COMPANIES/ORGANIZATIONS COMMENTS

CO21 – Virginia Natural Gas

RE: Docket No. CP15-554

KOP 38 (Raven's Roost Overlook). Non ACP sponsored image.

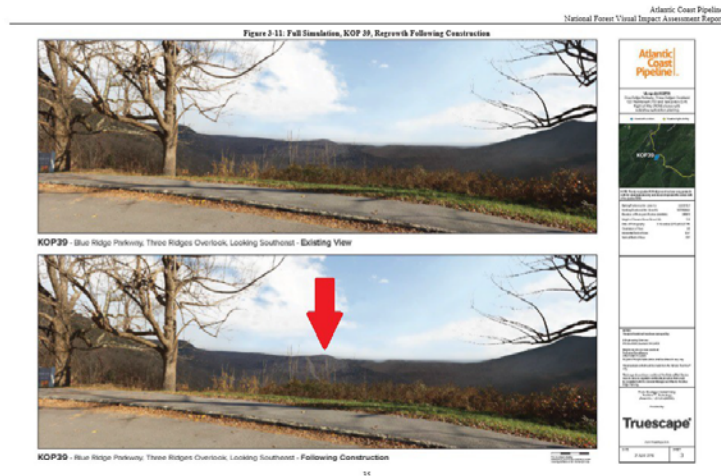
ACP- sponsored image taken from far away with bubble lens. Completely misleading and shows nothing.

Picture 2

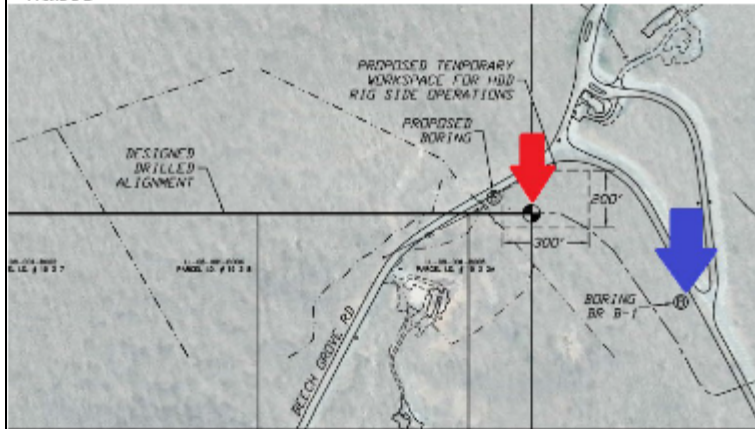
See picture below. Red arrow is HDD entry point. Blue arrow is under the road shallow bore that was presented as HDD entry point.

Picture 3

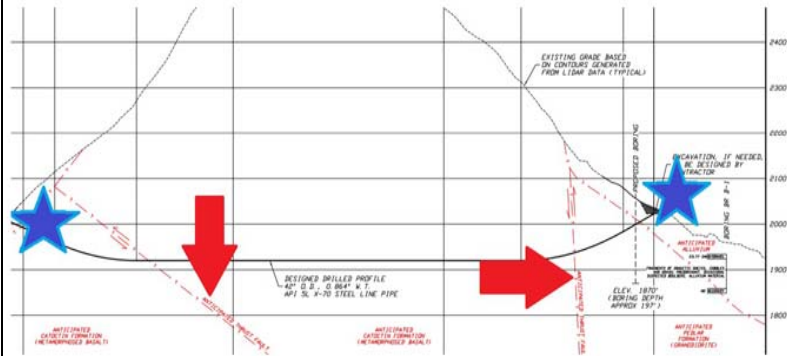
Fault lines are red arrows. HDD entrance and exit are blue stars.

You can not allow pipeline route that is solely hanging on low probability HDD drill. From the very beginning until now (several years) Dominion did not spend any money or time to deeper investigate this drill. Only a few superficial reports were done. They know about fault lines under the AT and Blue Ridge Parkway. So the plan from beginning is to say that HDD under AT is possible and after clearing large parcels of land on both sides of the Blue Ridge Parkway and Appalachian Trail and making several lazy attempts they will say that it is time for up and over (their contingency plan).

Figure 1. The Spruce Creek Tributary Conservation Site and the ACP

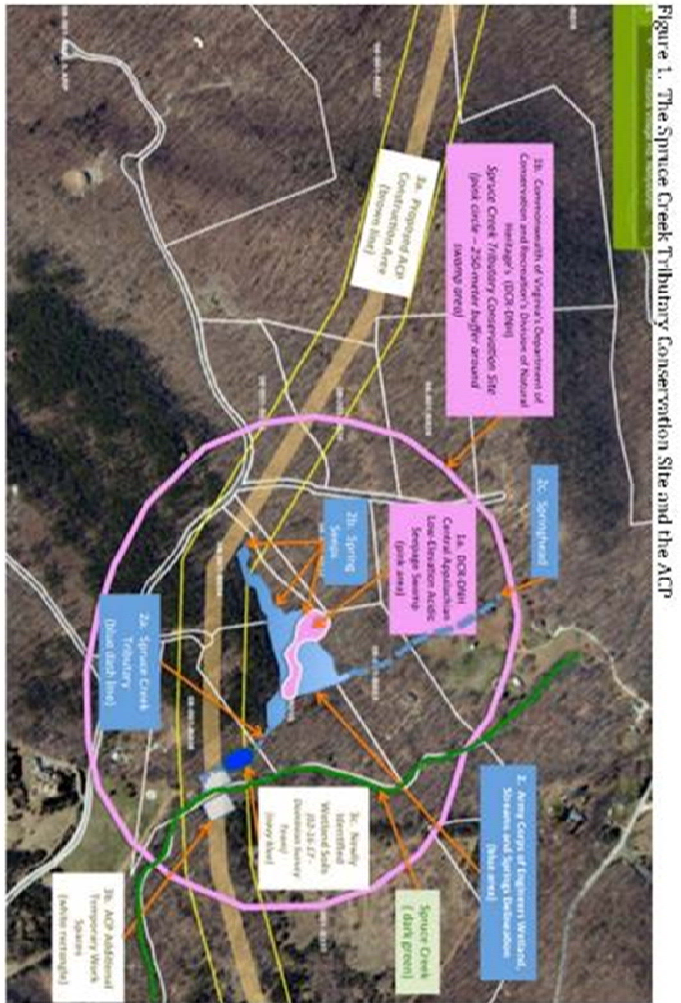
One example of this inadequate treatment of potential environmental impacts is the way the DEIS addresses (or does not address) the environmental impact of one of the Commonwealth of Virginia's Department of Conservation and Recreation's Division of Natural Heritage (DCR-DNH), the Spruce Creek Tributary Conservation Site⁴ (see Figure 1, below):

Figure 1 provides a graphic of the proposed ACP route as it passes through the Spruce Creek Tributary Conservation Site. The graphic uses different colors and notes to identify the key elements of the intersection of the proposed ACP route and the Conservation Site:

In Figure 1, the wetland spring seep shown on the western tip of the wetland is located within 29 feet of the center of the proposed ACP pipeline (see blue circle). The terrain between the wetland spring seep and the ACP pipeline climbs steeply between 25% (14 degrees) and 40% (22 degrees) and continues climbing, at 40% through the 125-foot construction area.

FIGURE 2 – Phases of the HDD process as presented in the HDD Design Report prepared for Dominion Transmission, Inc. by J.D. Hair & Associates, Inc. (7/27/16). The depiction shows the more-common use of HDD for installing pipelines under rivers or other water bodies.

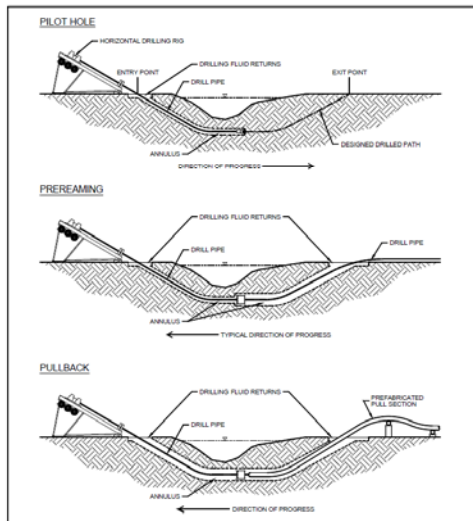
Our objection to the proposed Blue Ridge crossing is much like that for other areas of the ACP project. Large scale forest clearing and excavation on steep mountainsides presents substantial risk of erosion and sedimentation, alteration of runoff properties, and landslides. FERC, however, has failed to require detailed plans for construction and mitigation prior to publication of the DEIS, thereby precluding informed public and regulatory agency analysis of risks, alternatives, and mitigation measures.

The proposed HDD and contingency DPI installations will require extensive excavation for creation of level workspaces, access roads, and areas for pipe fabrication, testing, staging, and pullback. The information included in the DEIS, however, does not disclose

FIGURE 5 – Extreme pullback required for the proposed Blue Ridge HDD.

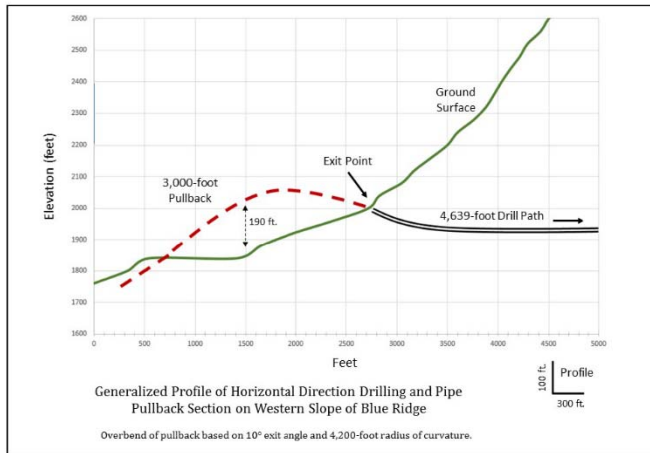
The proposed mountainside HDD operation greatly exceeds what is required for typical HDD operations on relatively flat ground. For example, see **Figure 6**.

FIGURE 7 – Profile of the proposed Blue Ridge HDD showing the exit-side suspension of pullback pipe based on a 1,500-foot bend radius instead of the correct 4,200-foot bend radius. From Geotechnical Site Investigation Report for Atlantic Coast Pipeline –

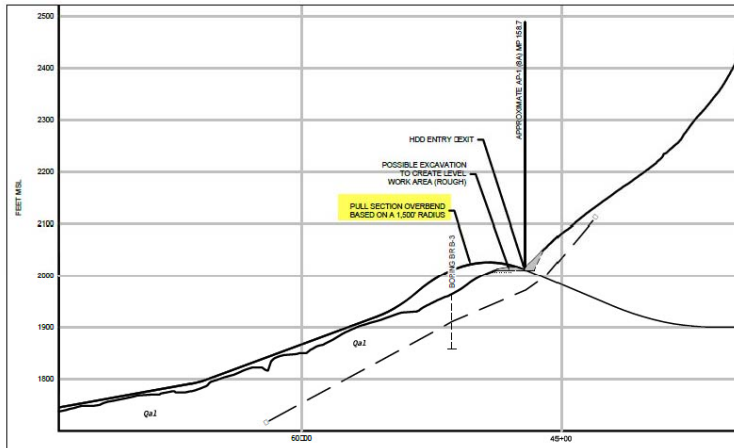
The fact that the suspension of pullback pipe and the magnitude of the related footprint were not addressed in the DEIS may be due to incorrect or misleading information provided to FERC by Dominion. The only depiction of the HDD pullback section included in Dominion submissions to FERC is based on a 1,500-foot bending radius (see Figure 7). This differs substantially from

Figure 3. Typical Pull Section Fabrication Site Plan

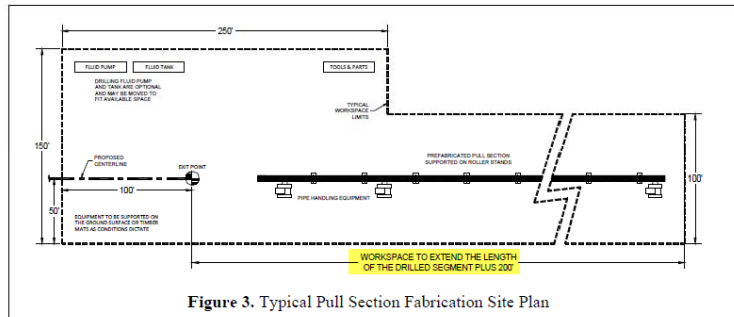
The length of the drilled segment for Dominion’s proposed HDD is 4,639 feet. The recommended pullback segment would thus be 4,839 feet. However, as indicated in the DEIS, the length of the workspace available for staging the pipe pullback is only about 3,000 feet, which makes fabrication, hydrostatic testing, and pullback of the recommended single continuous pipe string impossible.

FIGURE 11 – Locations of subsurface borings and geophysical surveys conducted for the proposed Blue Ridge HDD crossing. From Geotechnical Site Investigation Report for Atlantic Coast Pipeline Horizontal Directionally Drilled Crossing, Blue Ridge

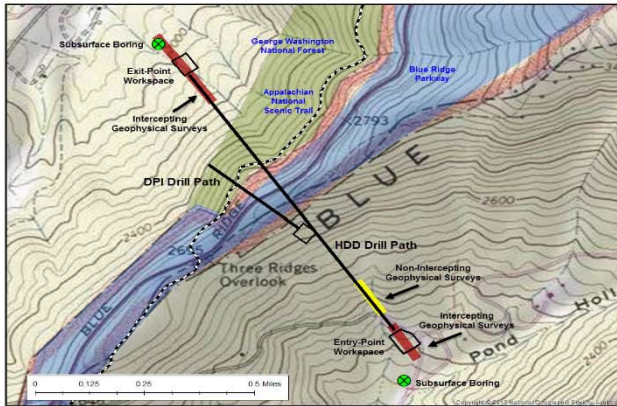
subsurface borings, the surveys indicated the presence of faulting and fractured rock at greater depth.⁶⁸ The survey results indicated that approximately 100 feet of fractured rock associated with a fault would be encountered at approximately 160 feet from the west-side exit point. Another fault of undetermined extent, was estimated to be present in the drill path beginning at approximately 425-550 feet from the ground surface at the east-side entry point.⁶⁹

FIGURE 12 – Interpreted results of geophysical surveys conducted at the entry and exit-sides of the proposed HDD drill path. (Based on Geophysical Study for a Proposed Blue Ridge HDD Crossing Augusta and Nelson Counties, Virginia, prepared by ATS International, Inc., 4/12/16.)

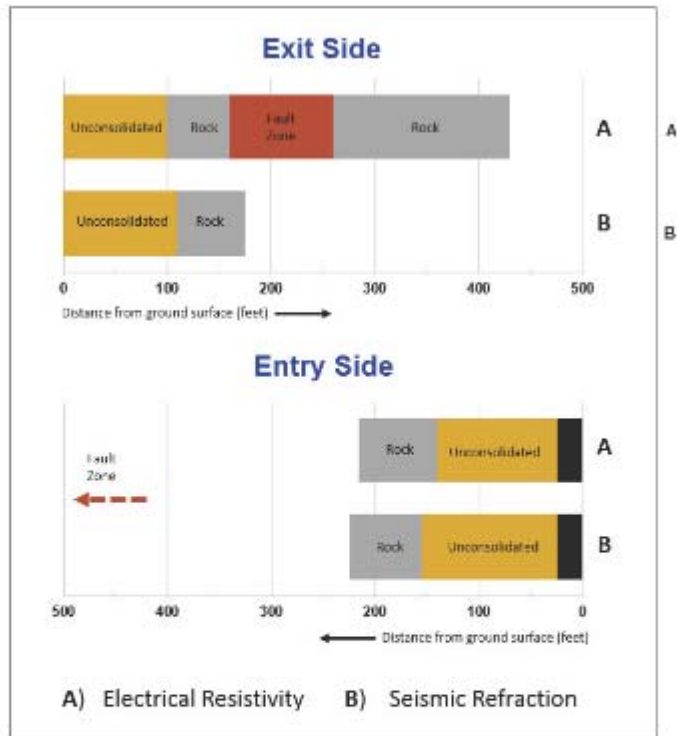
Figure 12 depicts the findings obtained through electrical resistivity and seismic refraction surveys.

FIGURE 13 – Construction-area slopes and access-road grade classification for the Blue Ridge HDD and contingency DPI operations area.

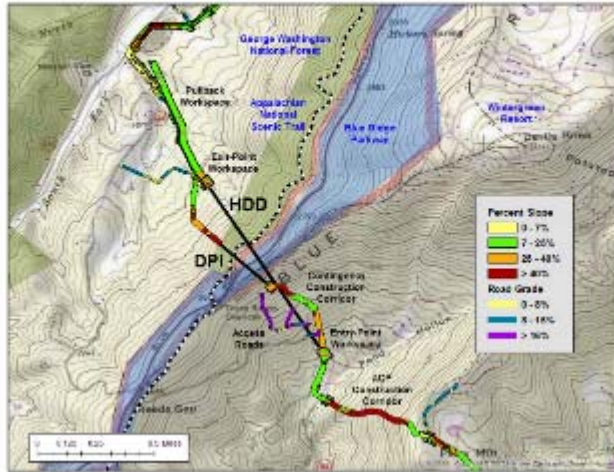
Figure 13 shows slope classes for the pipeline corridor, workspaces, pullback area, and access roads in the Blue Ridge HDD and contingency DPI areas.
